Date: 4/28/04

To: T10 Committee (SCSI)

From: George Penokie (IBM/Tivoli)

Subject: SAS UML Corrections

Figure 6 — SAS domain class diagram

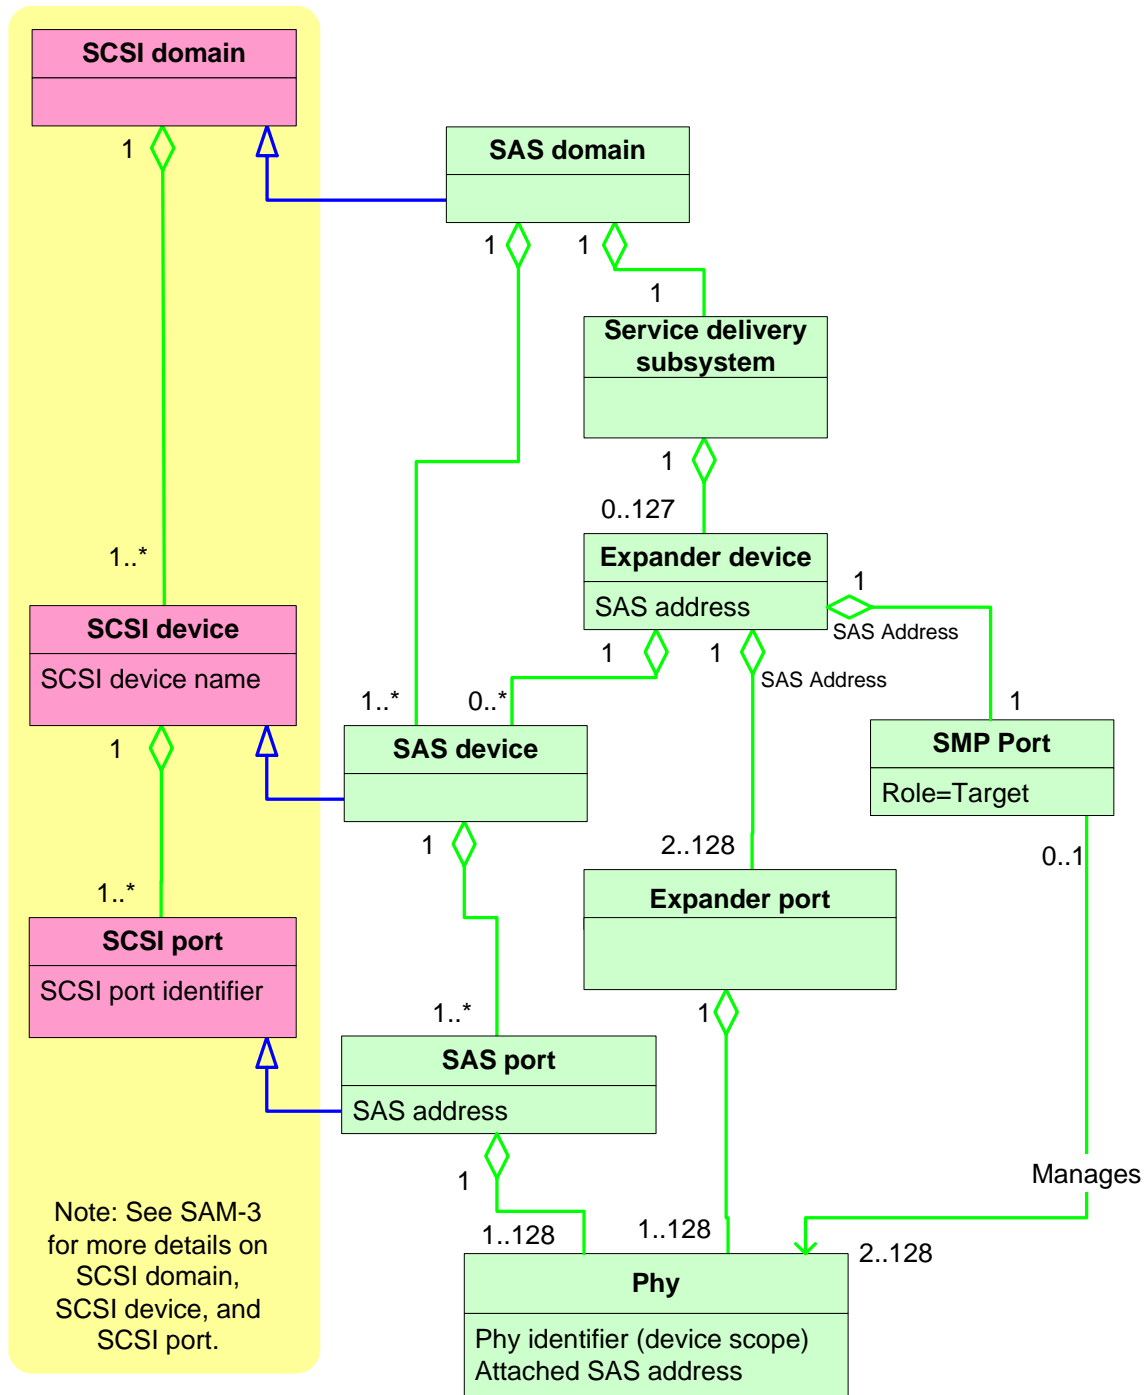
Figure 6 shows the class diagram for a SAS domain, showing the relationships between SAS domain, SCSI domain, service delivery subsystem, expander device, expander port, SAS device, SCSI device, SAS port, SCSI port, and phy classes. Relationships to ATA classes (e.g., ATA domain) are not shown in figure 6.

**Figure 7 — Phy classes**

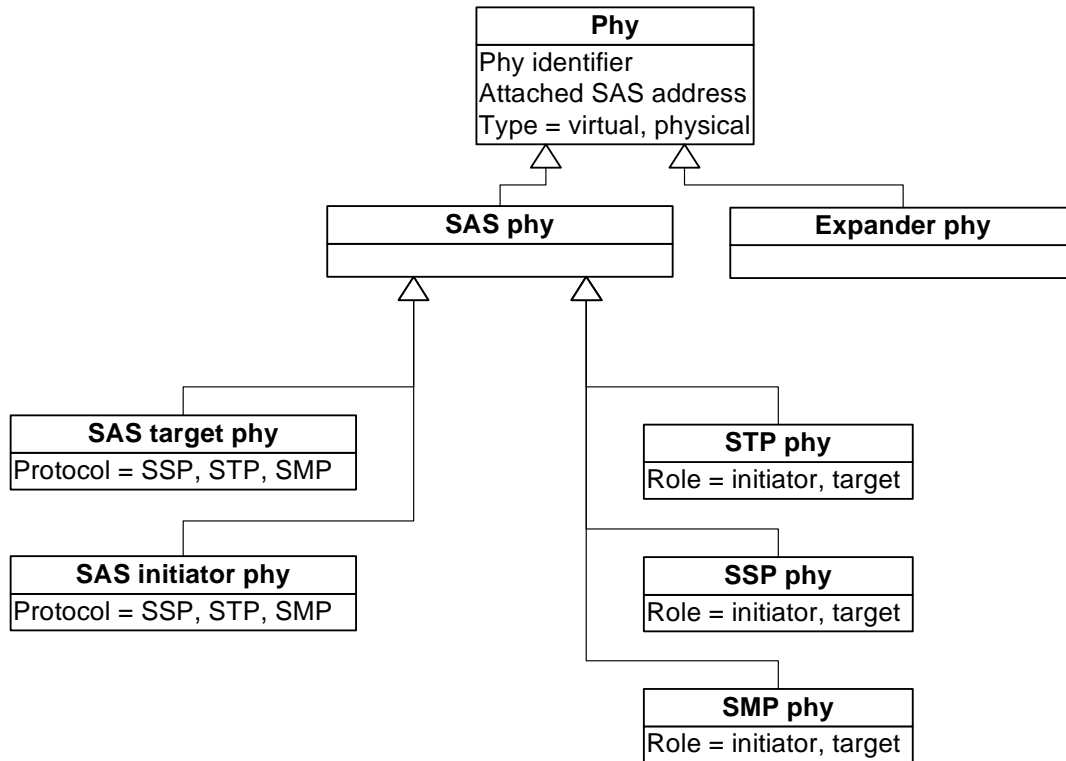
Figure 7 expands the phy class showing the relationships between the following classes:

- a) phy;
- b) SAS phy;
- c) SAS phy;

- d) SAS initiator phy;
- e) SAS target phy;
- f) SSP phy;
- g) STP phy;
- h) SMP phy; and
- i) expander phy.

SATA phys are also referenced in this standard but are defined by SATA (see ATA/ATAPI-7 V3).

**Figure 9 — Port classes**

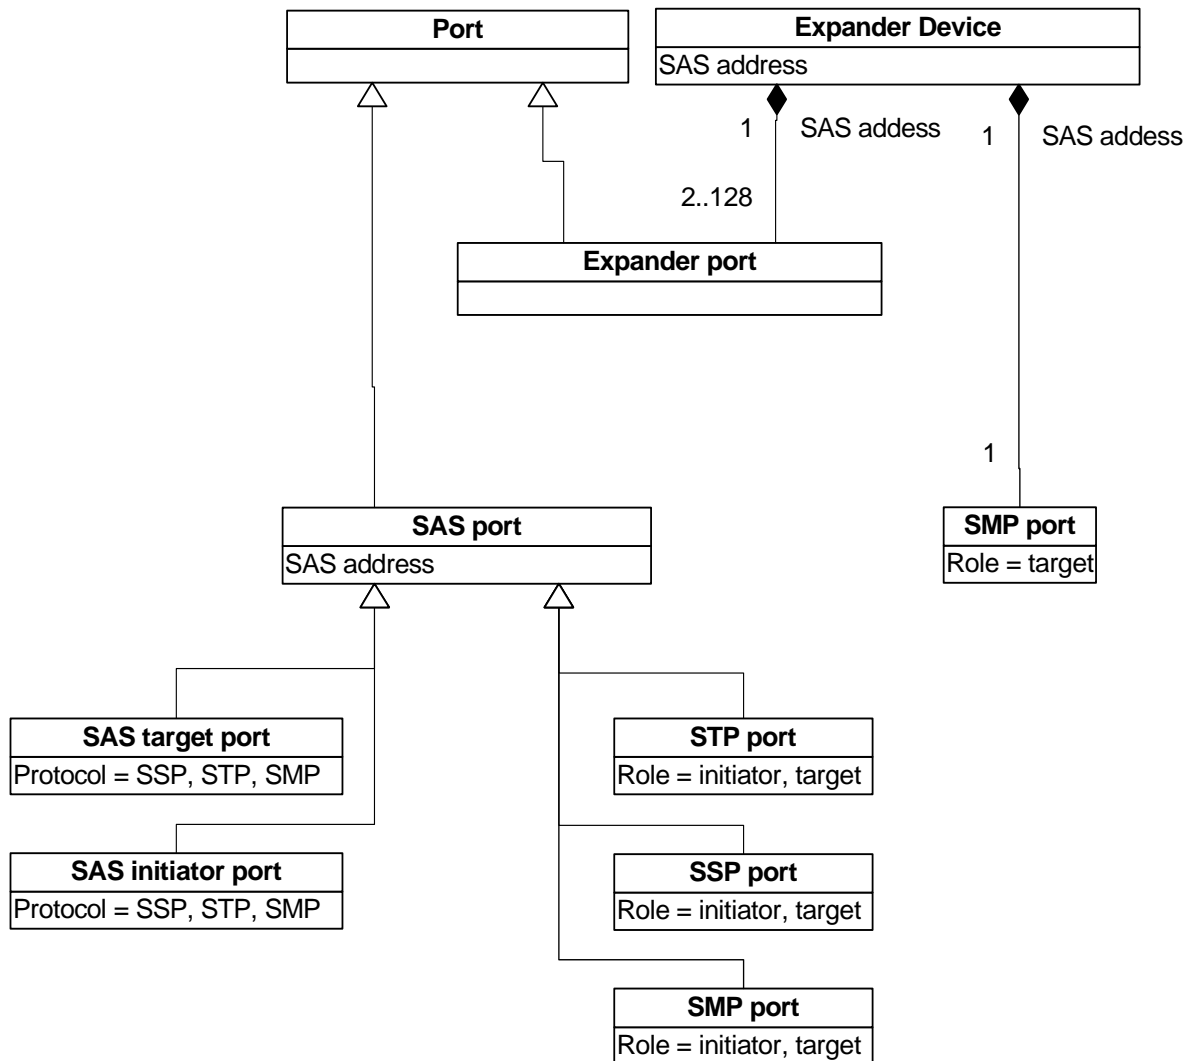
Figure 9 expands the port class and expander class to show the relationships between the following classes:

- a) port;
- b) expander device;
- c) expander port;
- d) SAS port;
- e) SAS target port;
- f) SAS initiator port;
- g) STP port;
- h) SSP port; and
- i) SMP port.

Figure 11 — Expander device classes

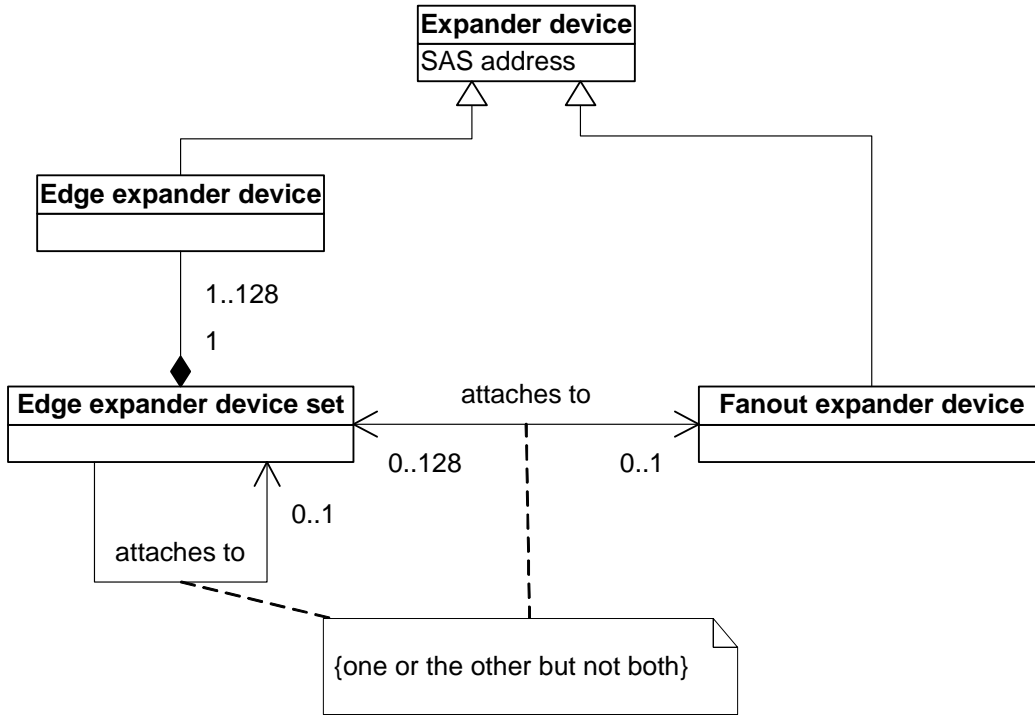
Figure 11 shows the expander device classes.

Figure 12 — State machines for SAS devices

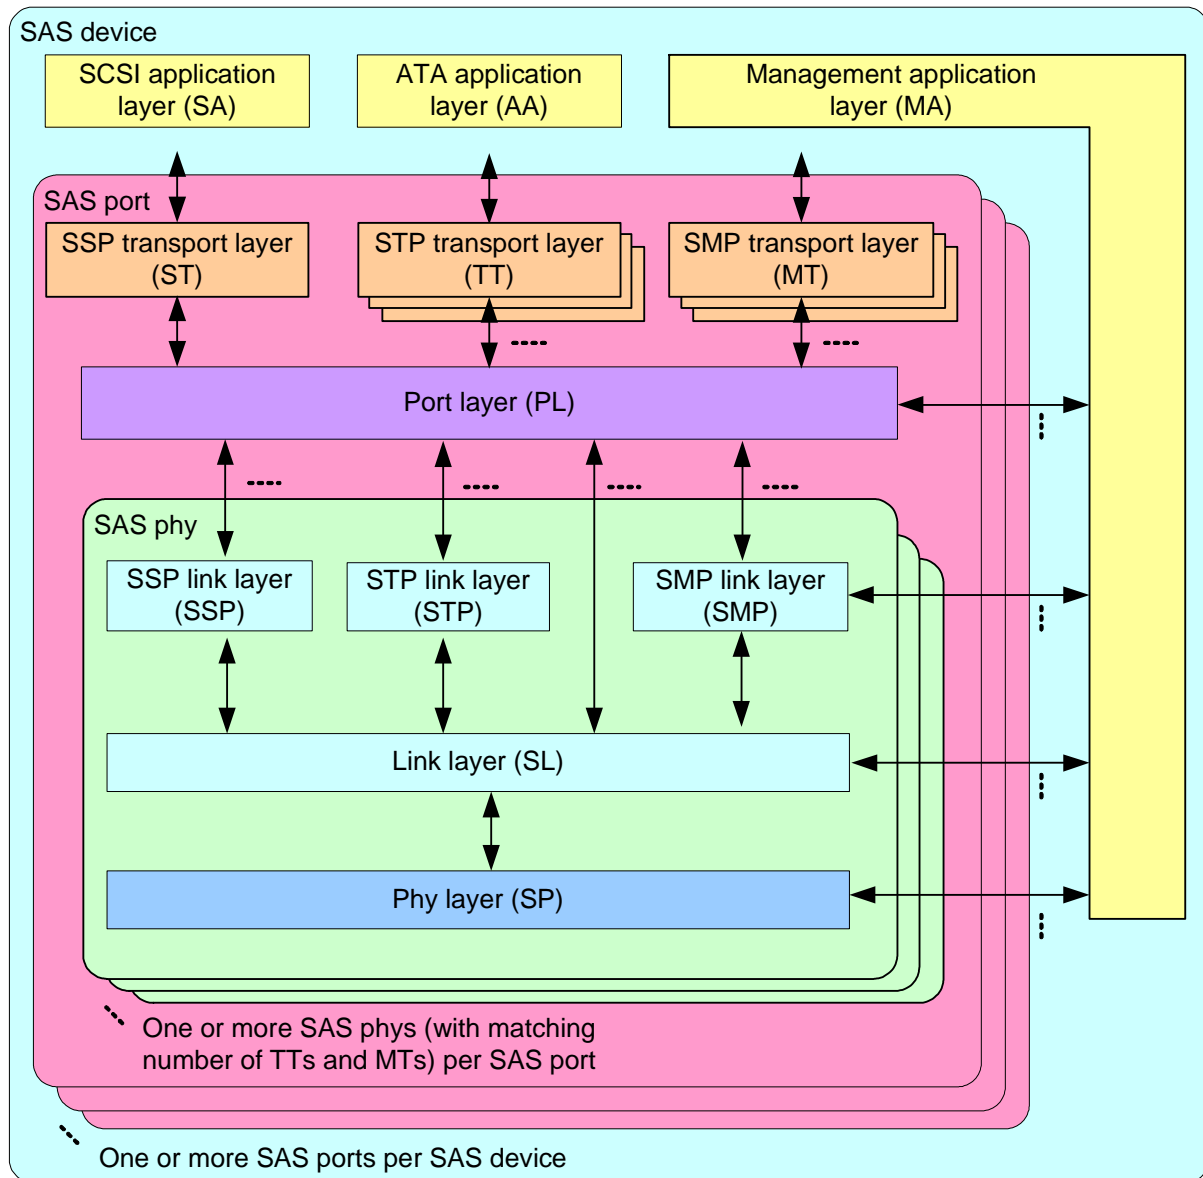
Figure 12 shows the state machines for SAS devices, their relationships to each other and to the SAS device, SAS port, and SAS phy.

Figure 13 — State machines for expander devices

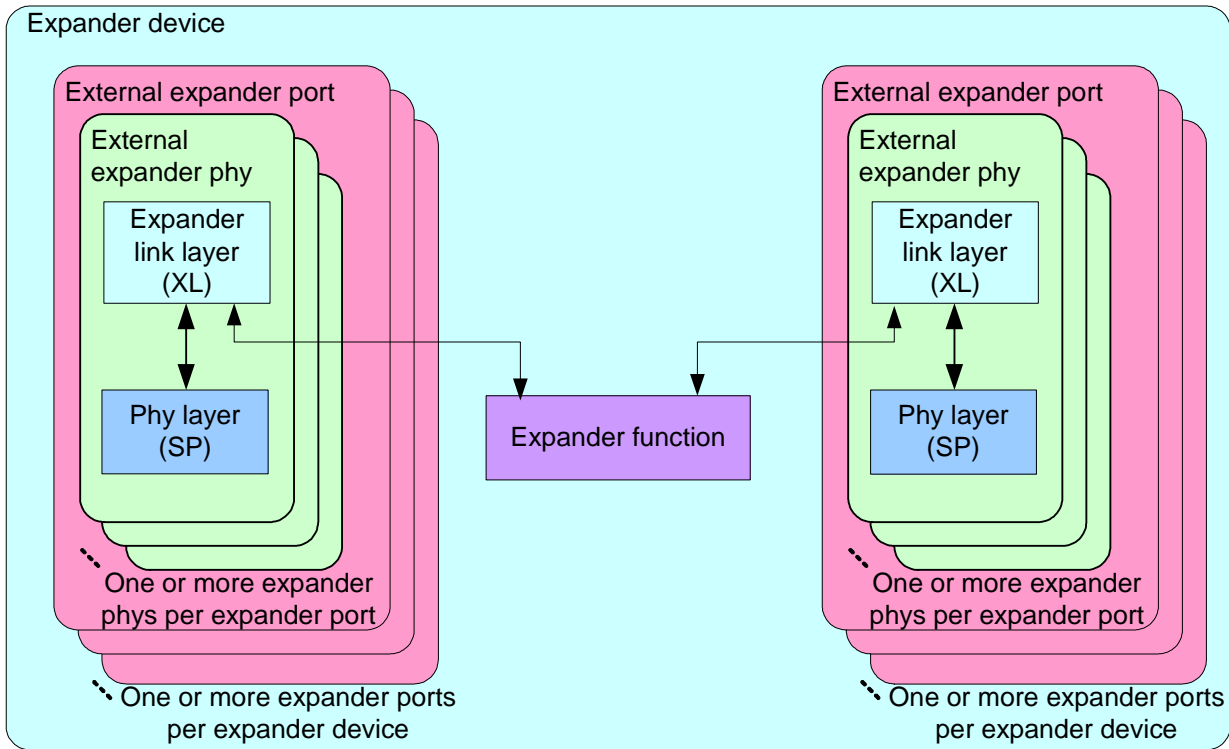
Figure 13 shows the state machines for expander devices, their relationships to each other and to the expander device, expander port, and expander phy. Expander function state machines are not defined in this standard, but the interface to the expander function is defined in 4.6.6.

Figure 14 — State machine and SAS device, SAS port, and SAS phy classes

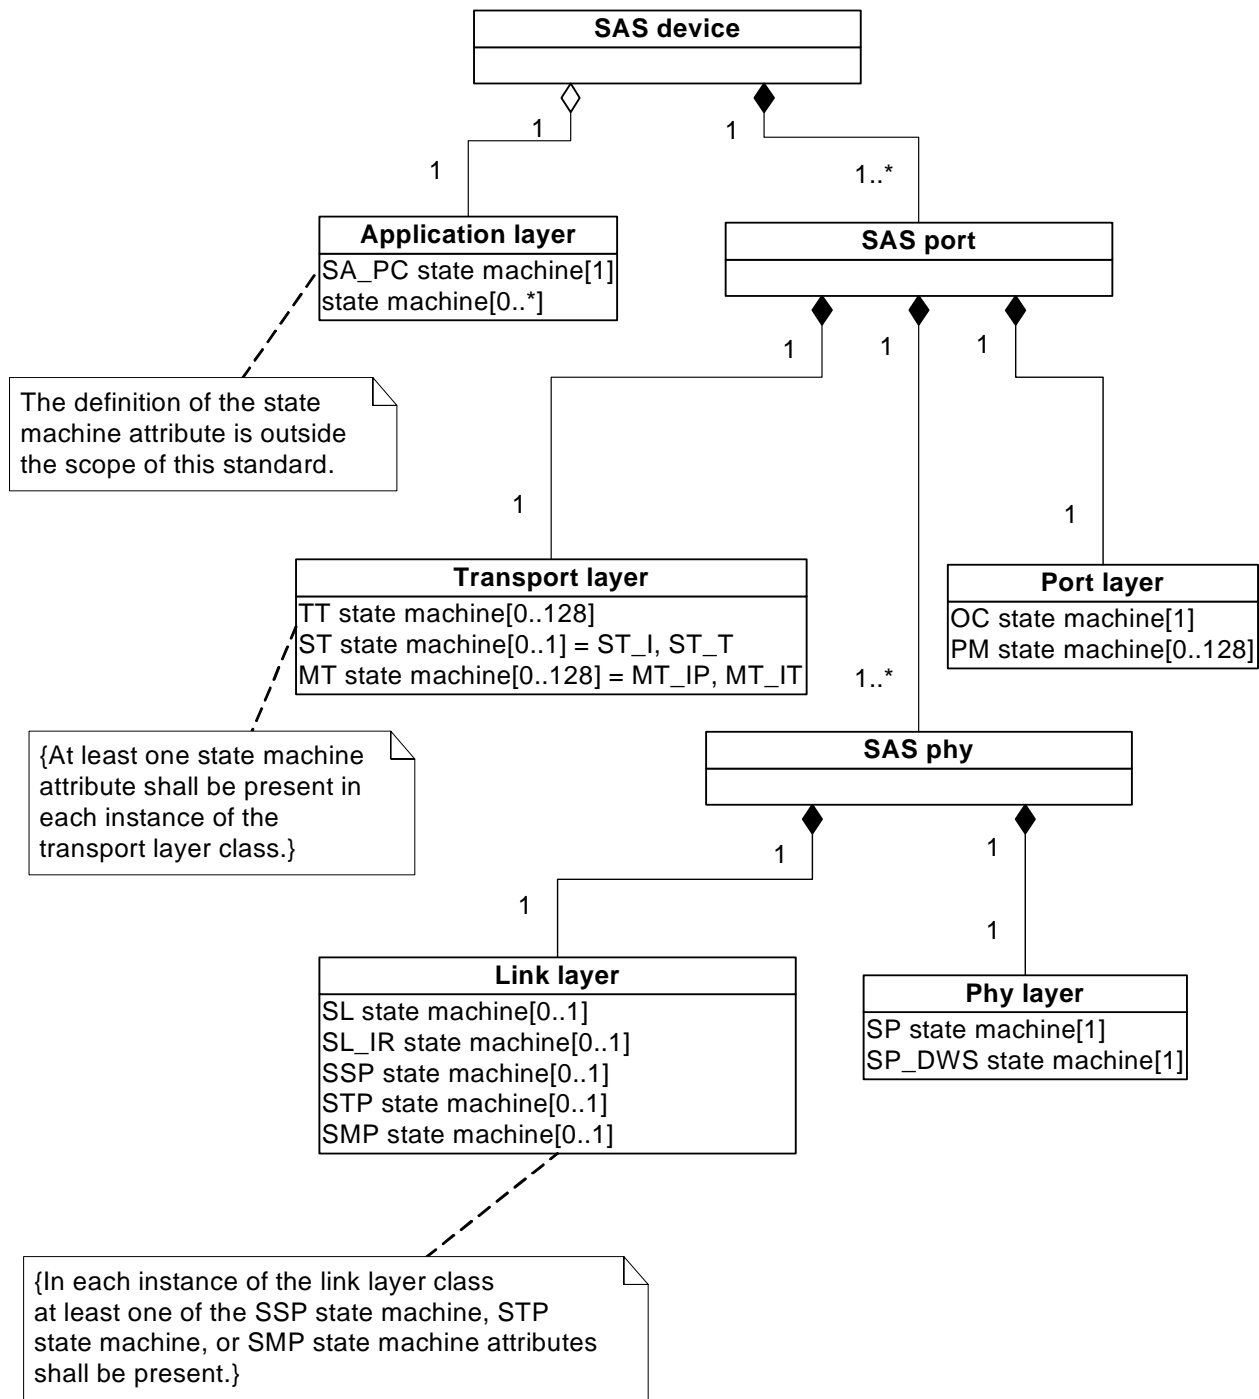
Figure 14 shows which state machines are contained within the SAS device, SAS port, and SAS phy classes.

Figure 15 — State machine and expander device, expander port, and expander phy classes

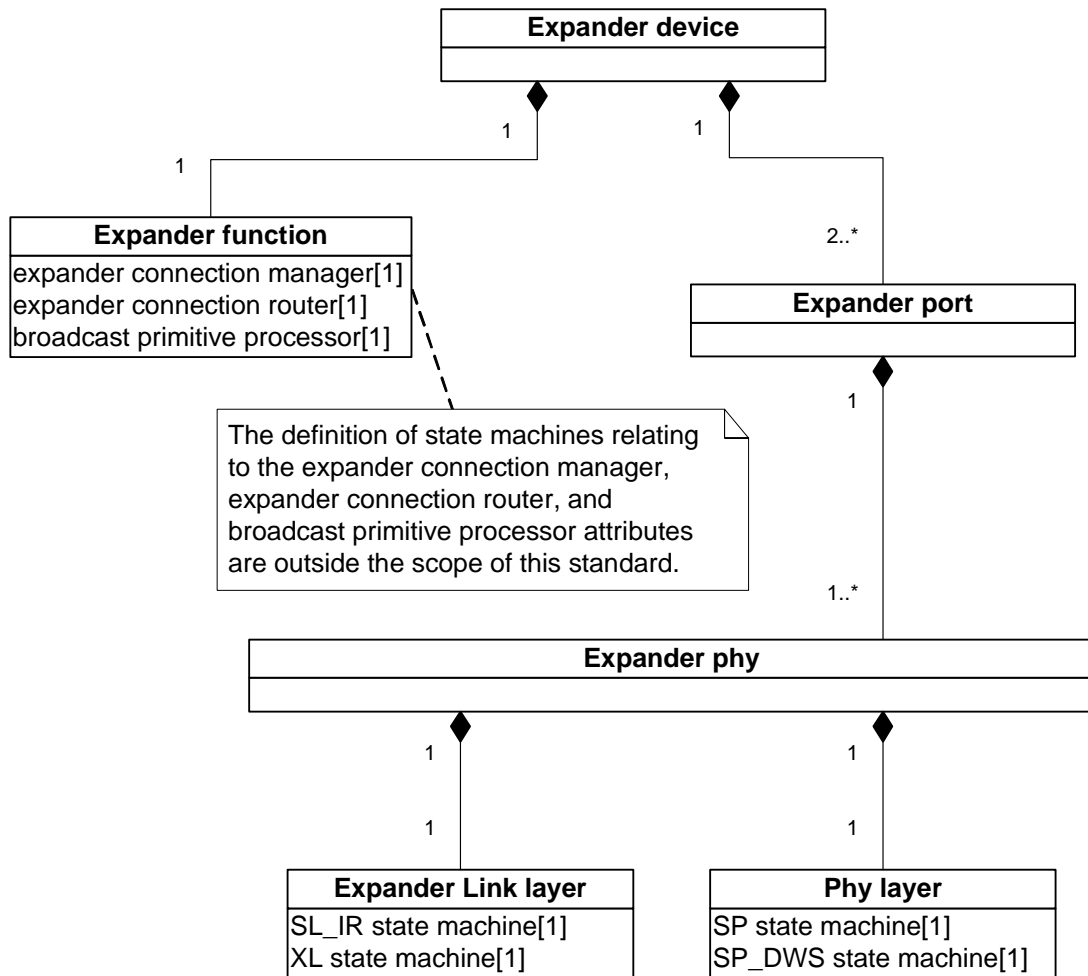
Figure 15 shows which state machines are contained within the expander device, expander port, and expander phy classes.
